UNITED STATES PATENT AND TRADEMARK OFFICE

APPLICATION NO.	FILING DATE	FIRST NAMED INVENTOR	ATTORNEY DOCKET NO.	CONFIRMATION NO.
10/568,703	09/25/2008	Lars Bjorkholm	10400-000213/US	4723
30593 7590 05/31/2011 HARNESS, DICKEY & PIERCE, P.L.C. P.O. BOX 8910 RESTON, VA 20195				
EXAMINER				
HYLTON, ROBIN ANNETTE				
ART UNIT		PAPER NUMBER		
3788				
MAIL DATE		DELIVERY MODE		
05/31/2011		PAPER

Office Action Summary

DETAILED ACTION

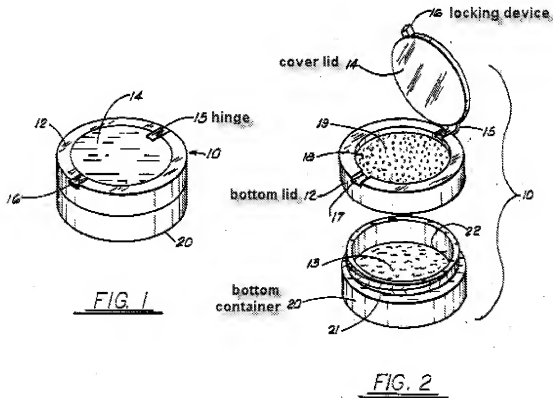
11. Claims 1,3, and 9 are rejected under 35 U.S.C. 103(a) as being unpatentable over Vetter (US 4,165,815) in view of Alexander et al. (US 6,712,076). Reference should be made to the following annotated figures of Vetter for the structural features disclosed therein.

Vetter does not disclose the hinged joint comprises pins snapped into corresponding recesses in the bottom lid. See column 2, lines 33-35 which discloses the cover lid **14** forms a tight unit with the bottom lid **12** to prevent the "leaking of the remover contained within sponge **18**" and column 2, lines 42-44 which discloses the bottom lid **12** forms a tight unit with the container (or case) **20** to "prevent escape of cosmetic product 13 from the case **20**".
